Christchurch City Council

re: Building Permit Application No. 680

CHRISTCHURCH PRESS CO LTD — PARAPET SUPPORTS

PRESS BUILDING

Photo Reference:

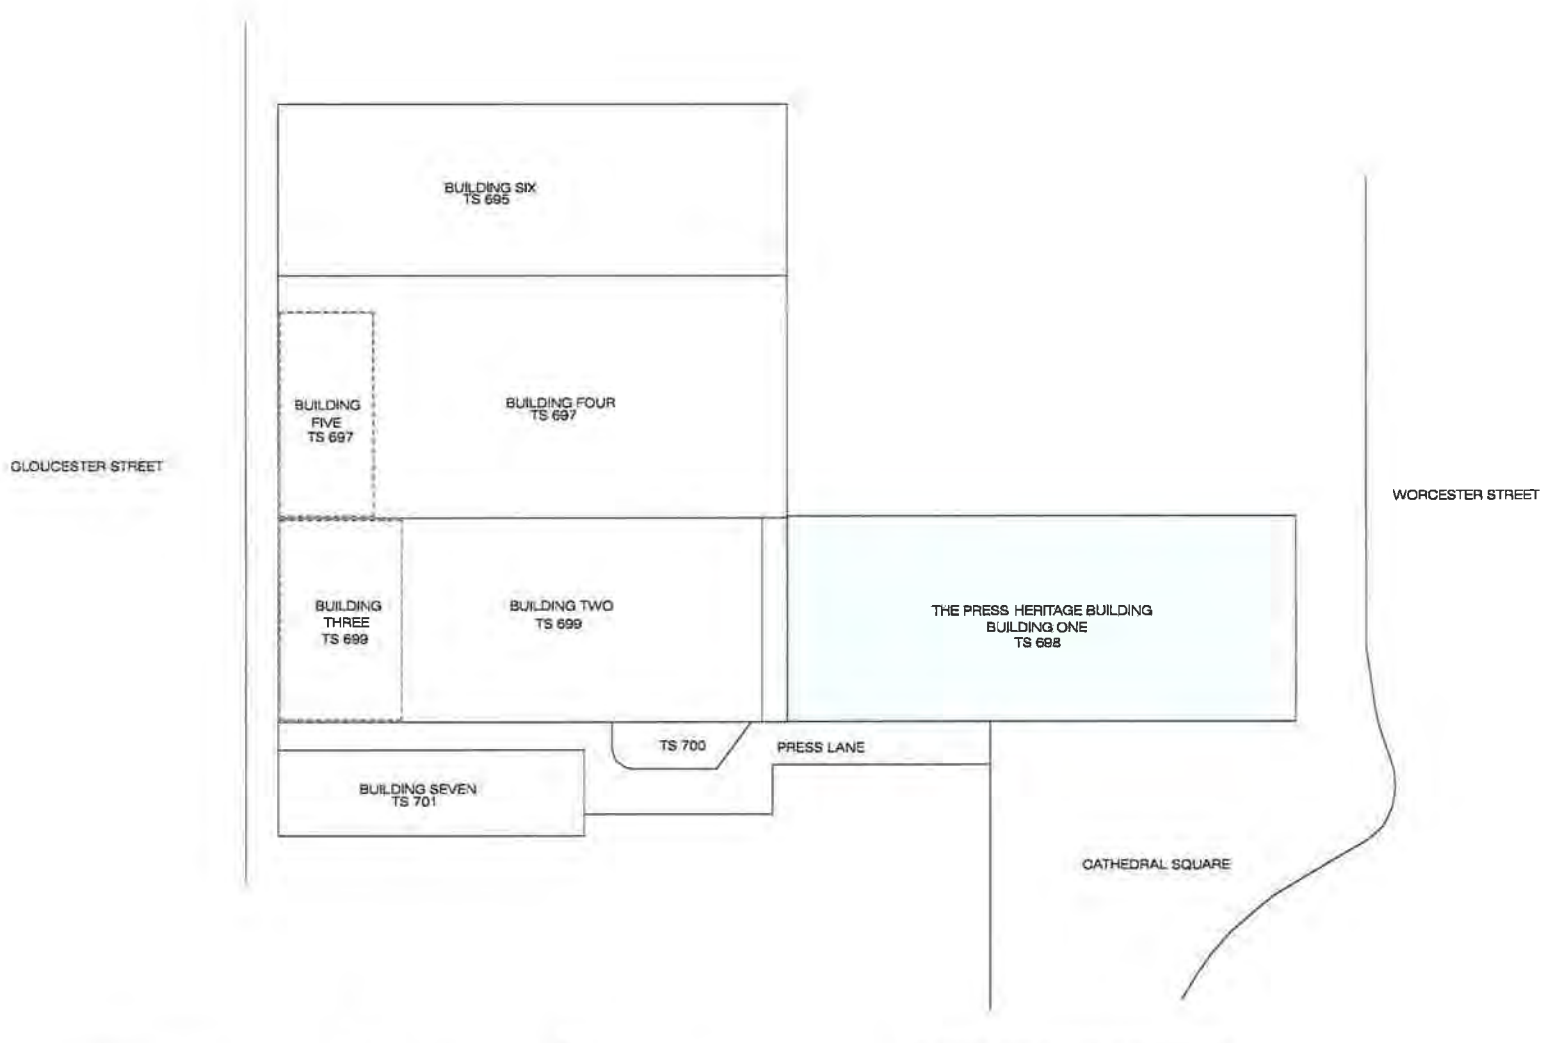
Parapet: Very high e hazardous, some securing done
 Chimney: _____
 Cornice: _____

Loose Masonry: Significant / ~~Noticeable~~ / Minor.
 Mortar Deterioration: Significant / Noticeable / Minor.
 Cracking: Significant / Noticeable / Minor.

Comments: 4 storeys e one basement level,
 extremely ornate, especially at roof level.
 A tower from the first floor up to a floor
 above the roof-level (see photos).
 Stores are well-weathered.

Sketch (optional)

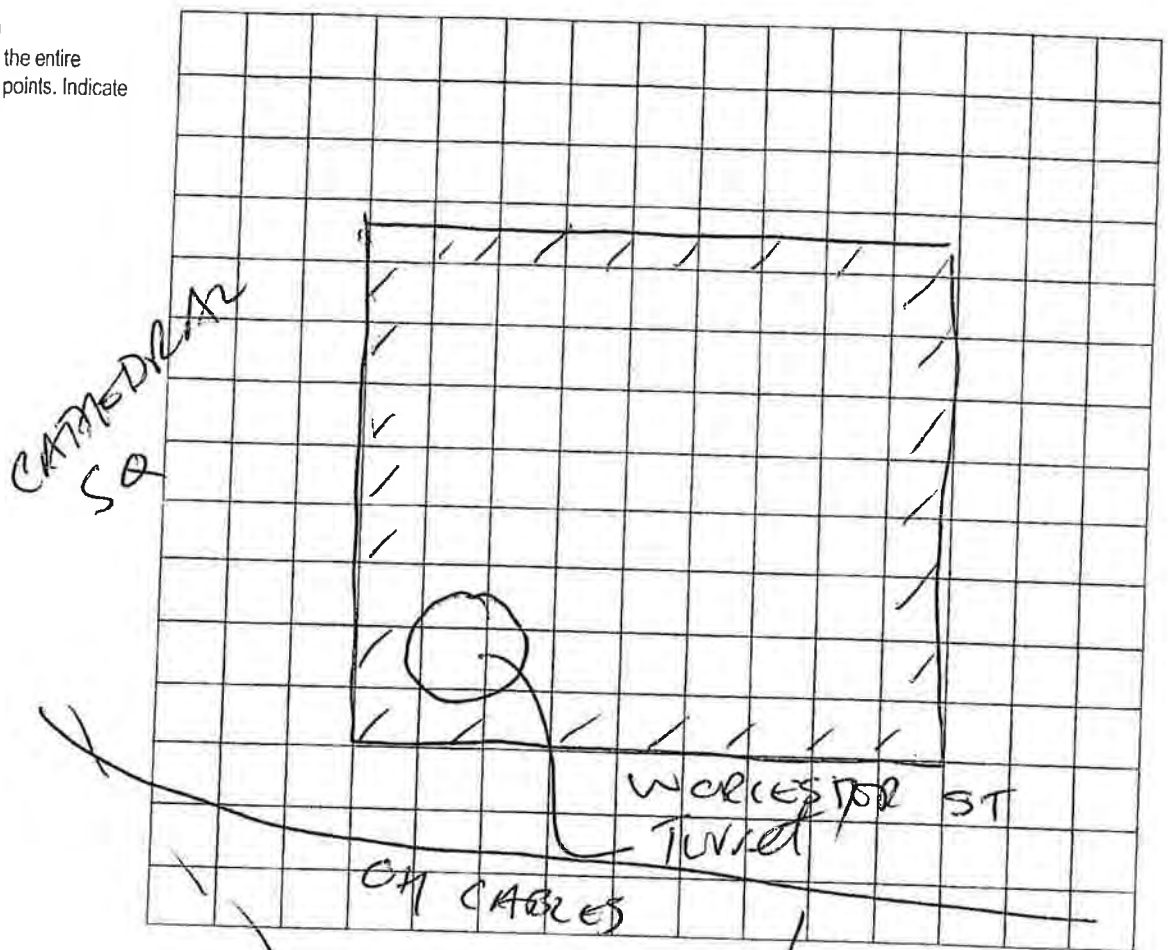
1. Live cables for trams need to be switched off for crane.
2. crane to remove turret steelwork which is loose.
3. Fence to close off area below damaged masonry wall.

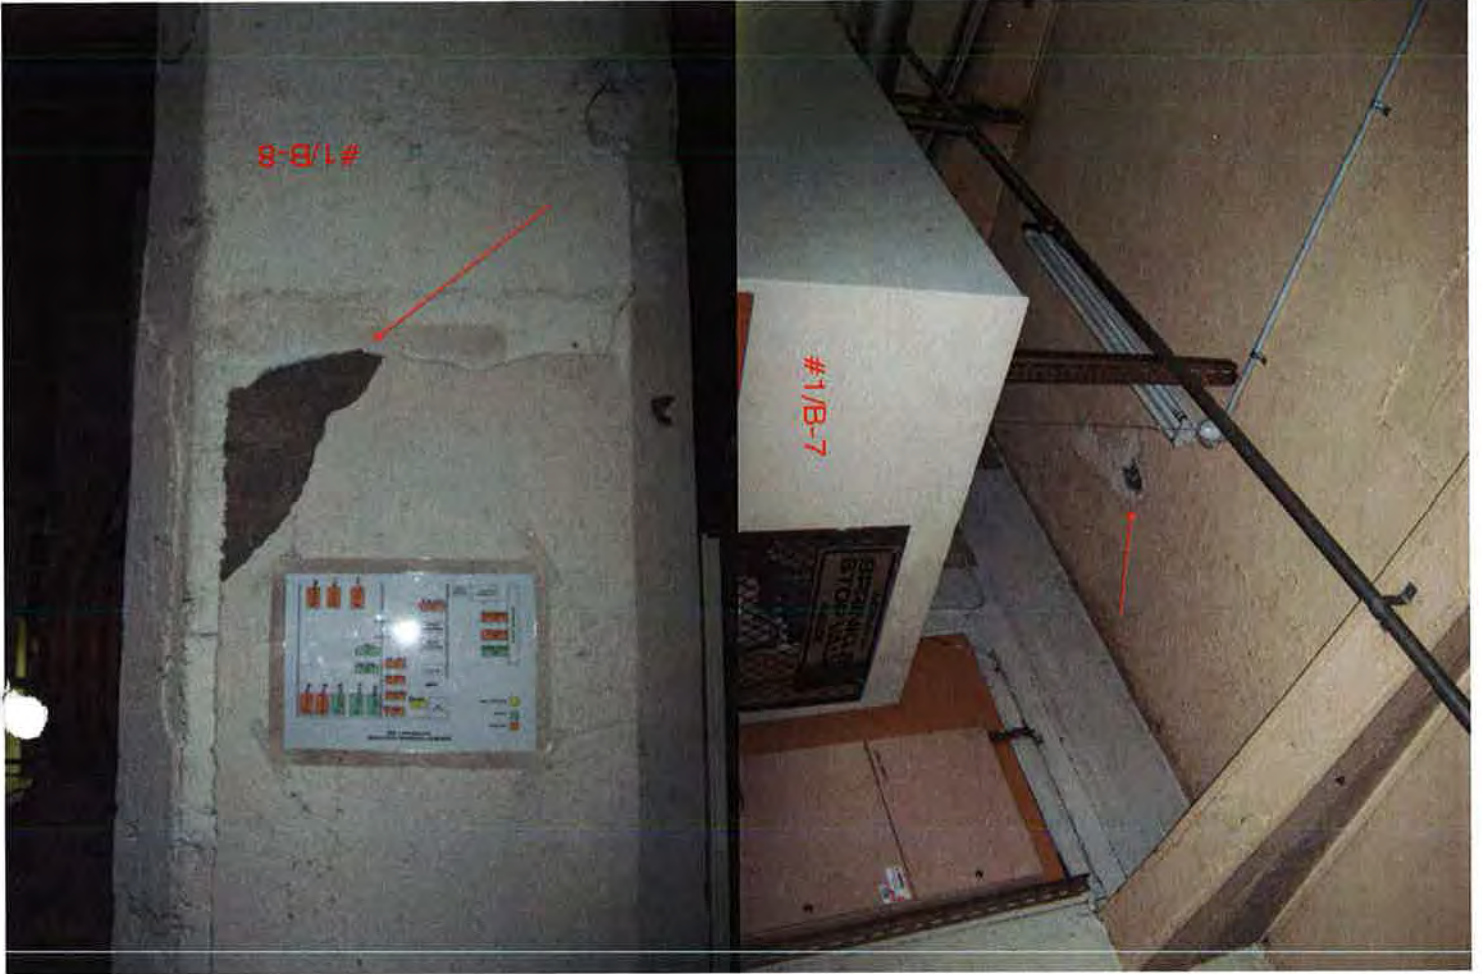
Damage not recorded on plans:

#1/F-34	Paint cracking
#1/F-47	Paint cracking
#1/F-55	Paint, possibly stone cracked

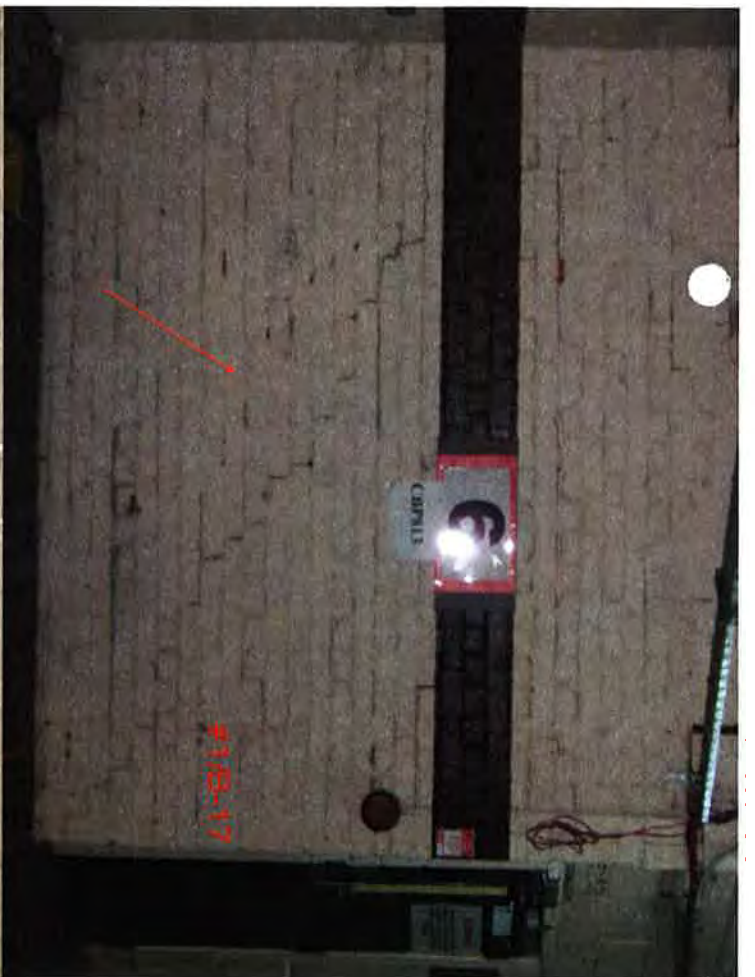
To the south of the building, westerly corner, next to the turret, some major cracking was observed running along the whole height of the façade as one continuous fault line through the brick and stonework.

SECTION E-F

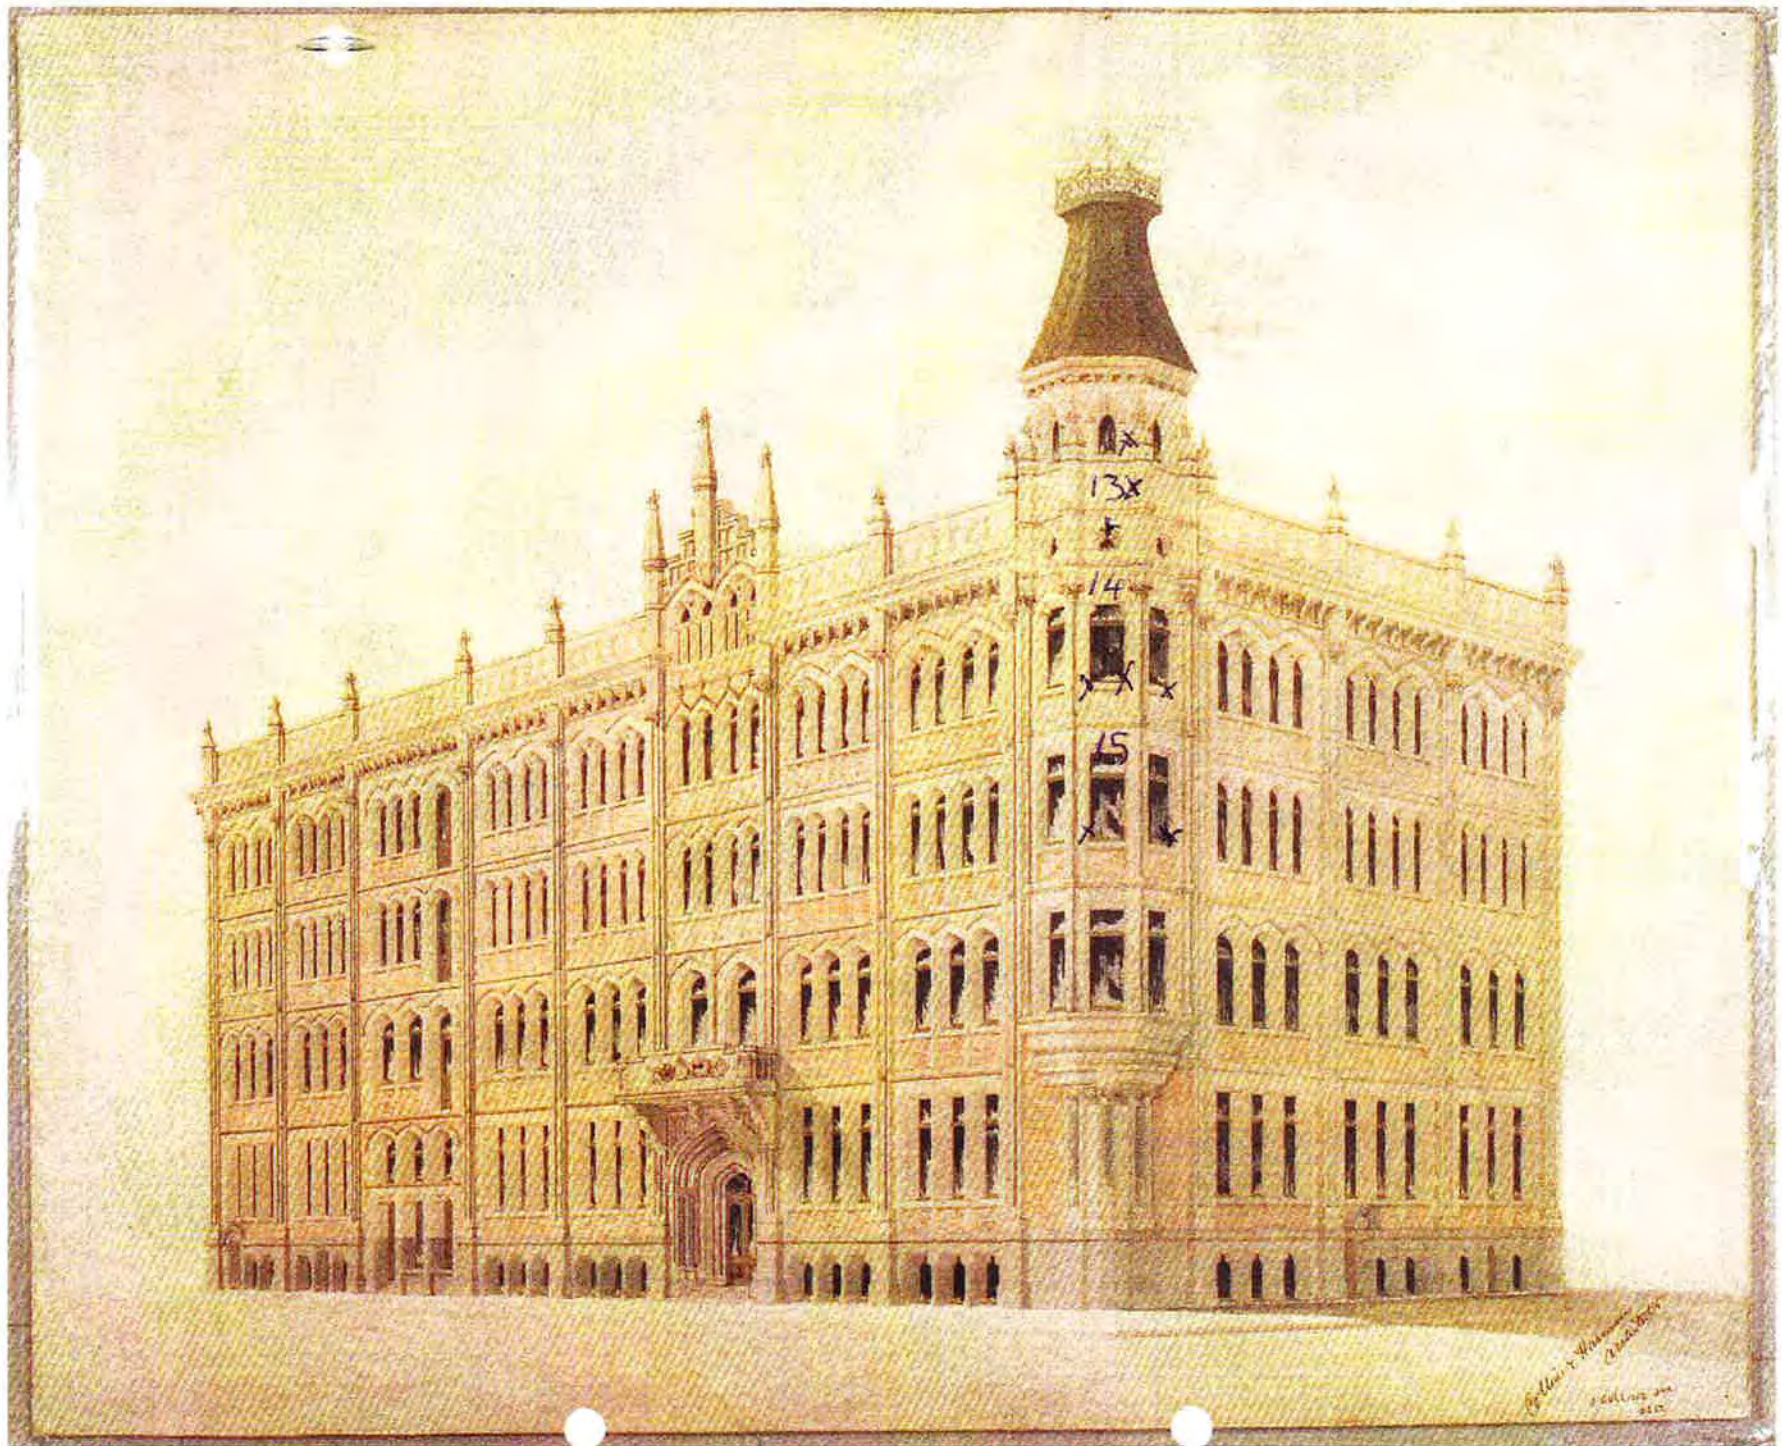
- 1 - car park side gap between sand stone & brick Top corner
- 2 - sand stone joints in columns movement - chipped
crack Top & Btm of column
- 3 - cracks sand stone ~~in~~ window columns both outer sides at base
- 4 - columns moved still solid 3 stones high right side
of centre column
cracks sandstone window columns both outer sides at base
Flaking paint around columns
